Blumel Hall

Re-pipe & Remodel

PORTLAND STATE UNIVERSITY

Revisions :	Date :
1 5 / 4 / 12 ADDENDUM #1	4/17/12

3
15
PIPE HANGER DETAIL
N.T.S.

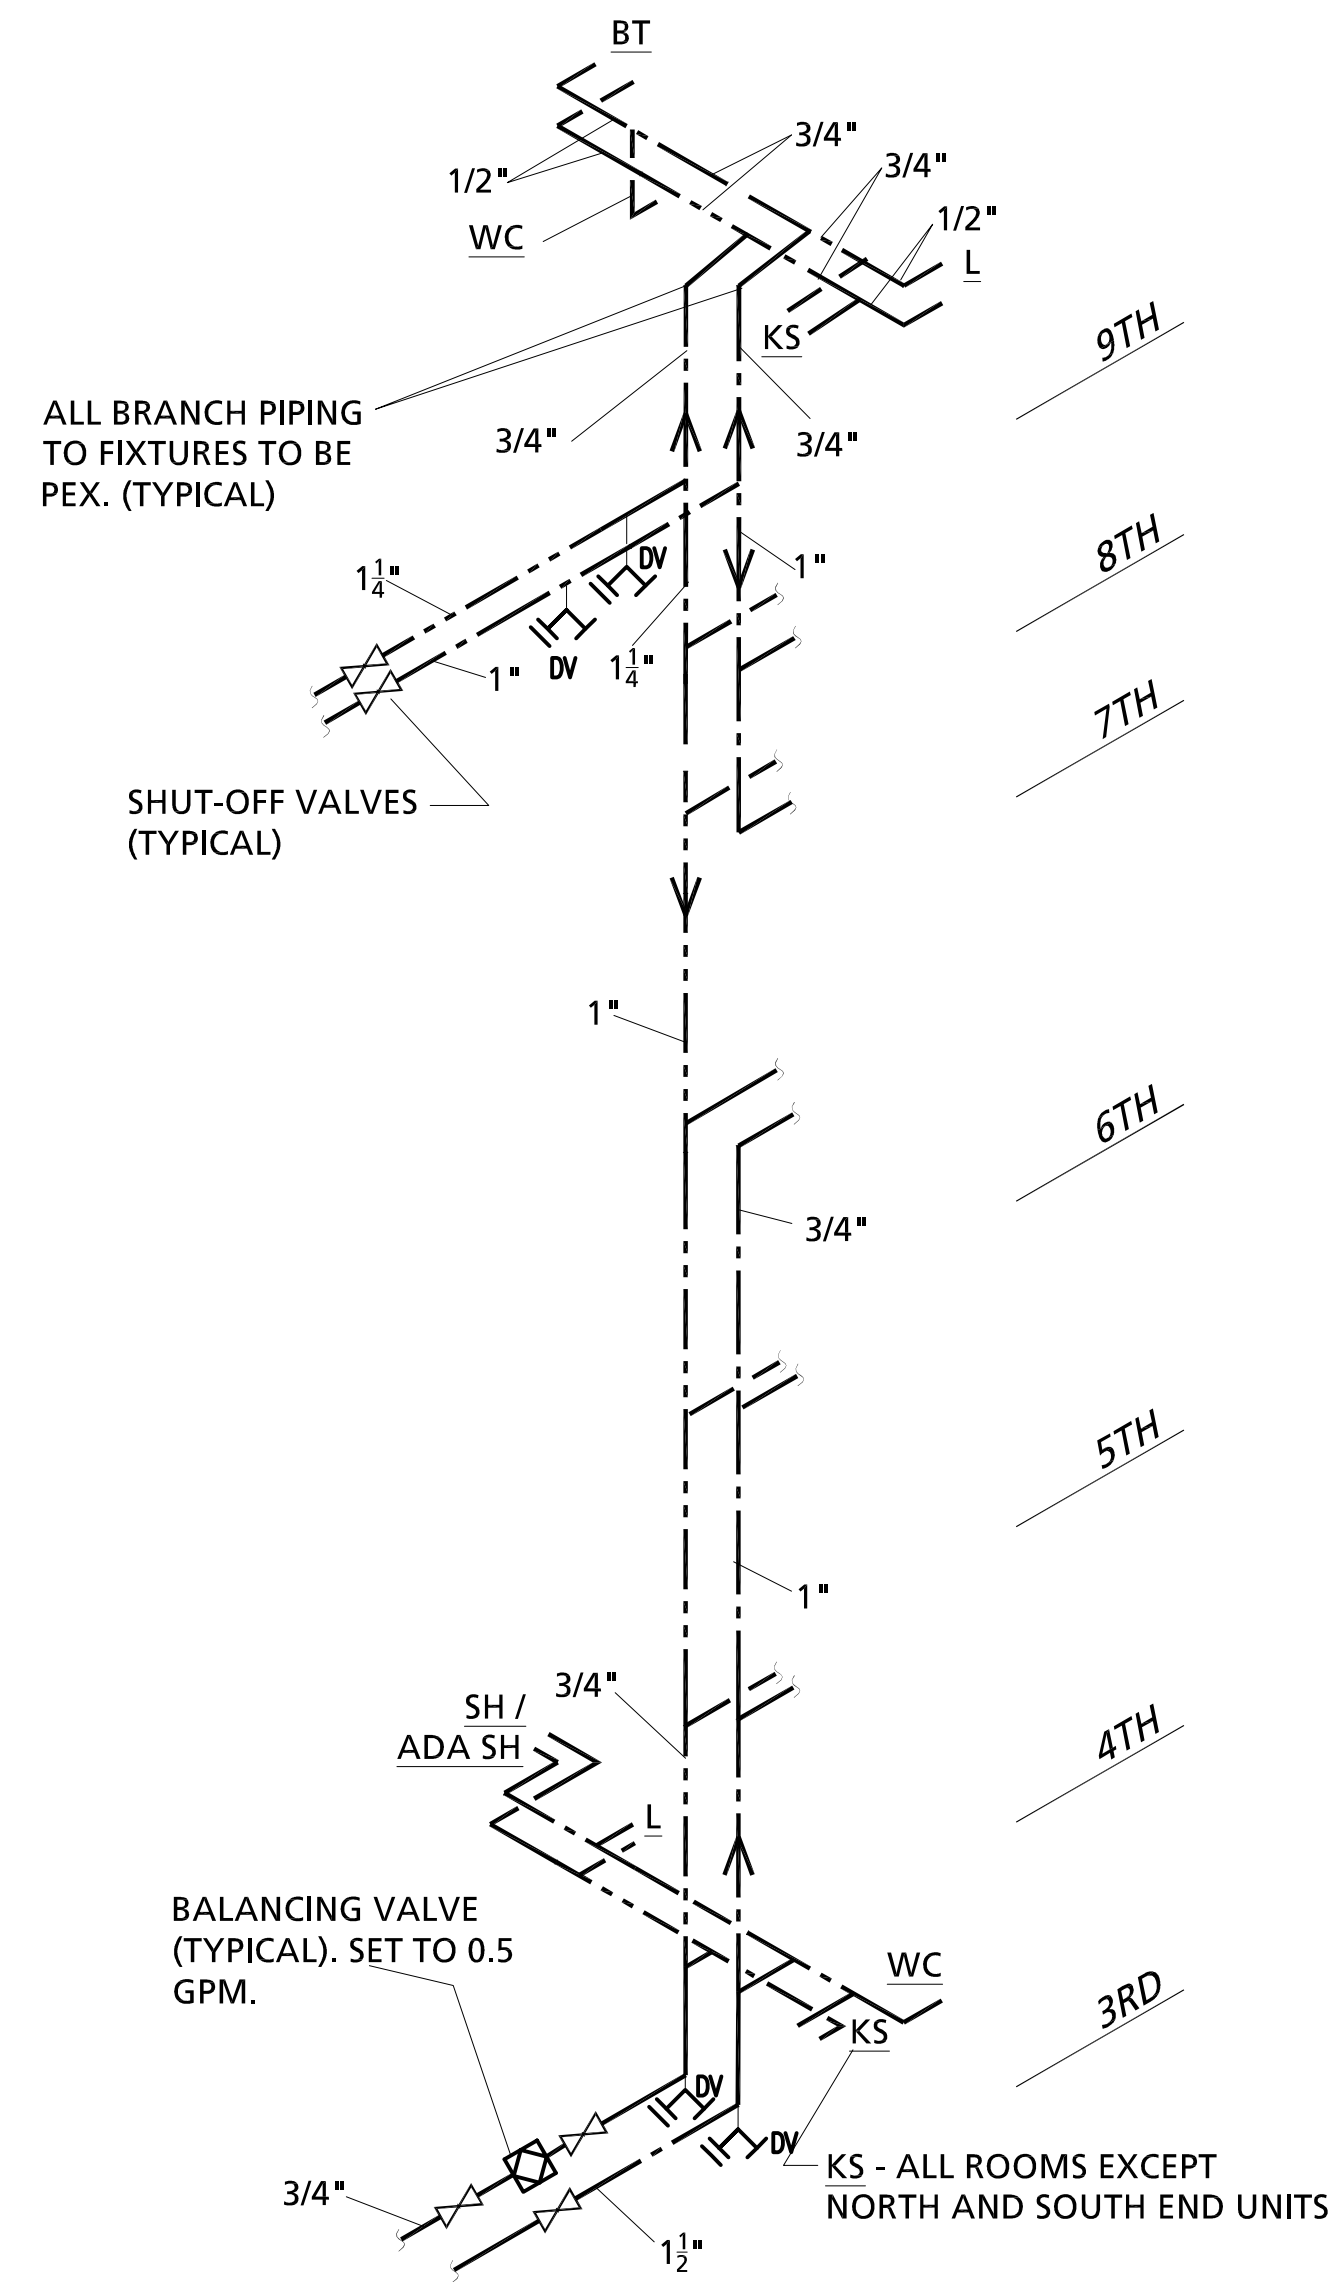
1. Added structural verbiage to details 3/15 and 9/15.
2. Added general structural note.
3. Added general unistrut note.

E4.0

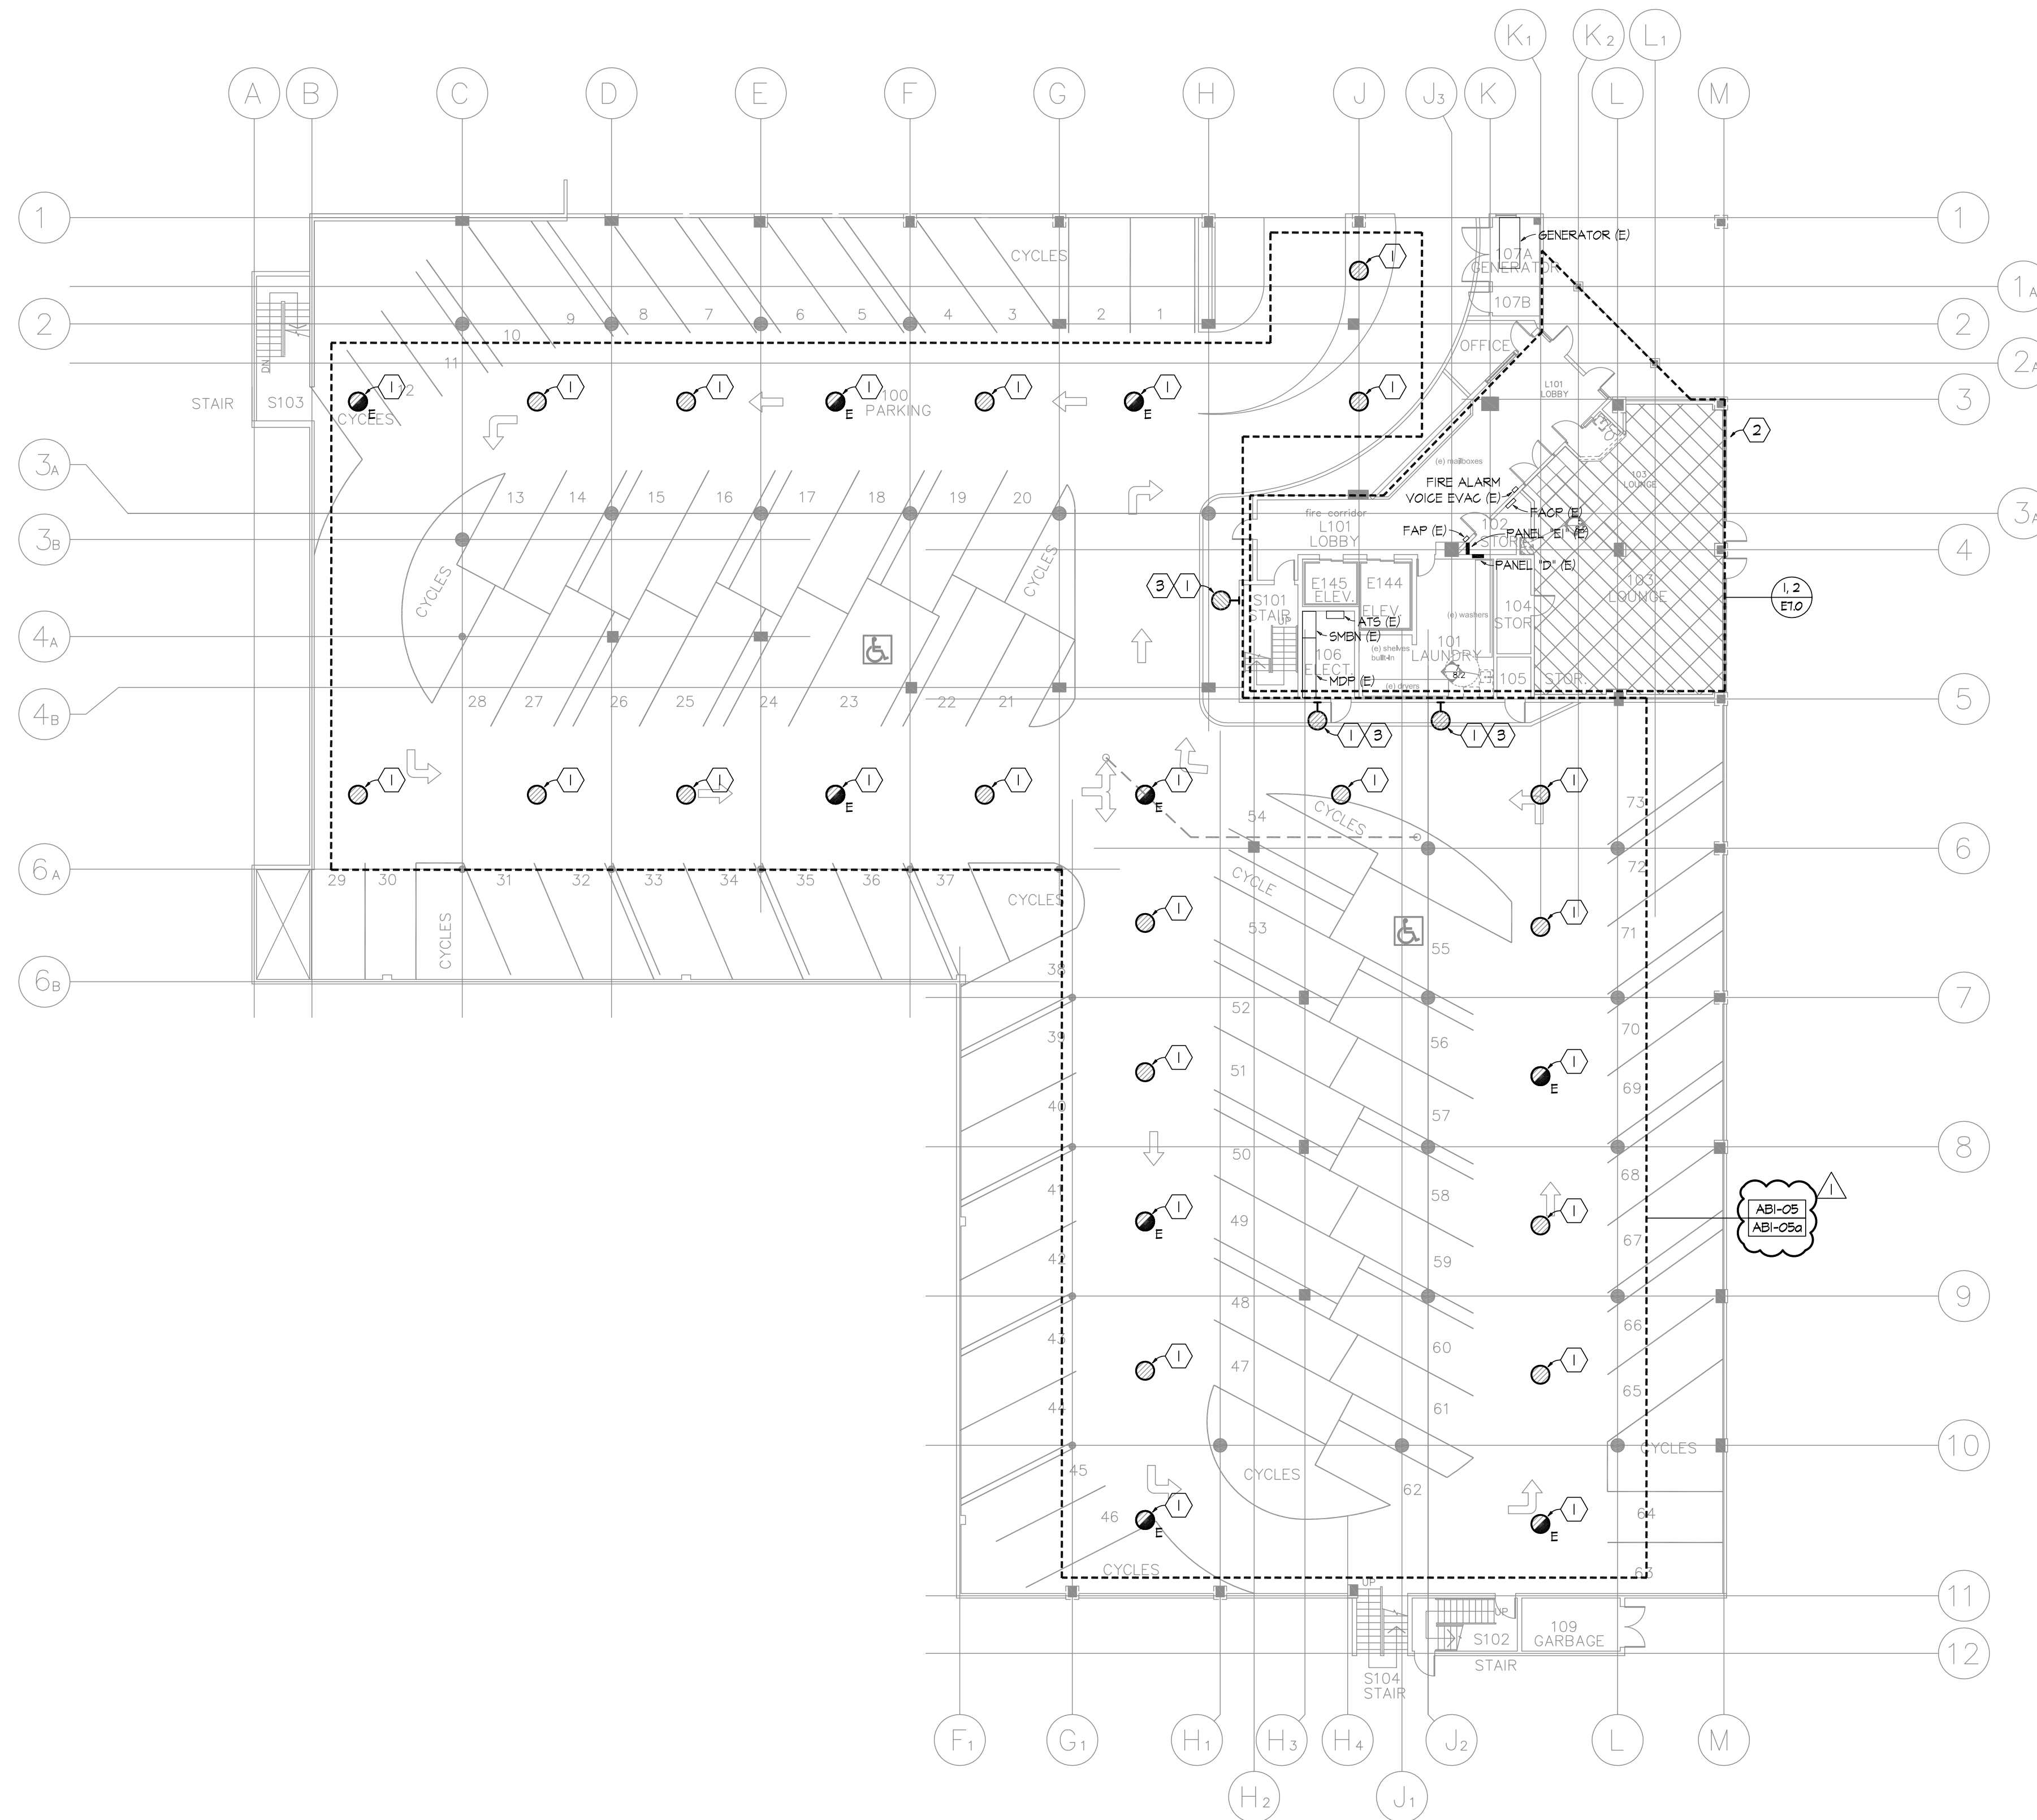
22. E4.0: Revise 1st Floor Electrical Demolition Plan for ABIs.
23. E4.1: Revise 1st Floor Lighting New Work Plan for ABIs.
24. E5.0: Revise 2nd Floor Electrical Demolition Plan for ABIs.
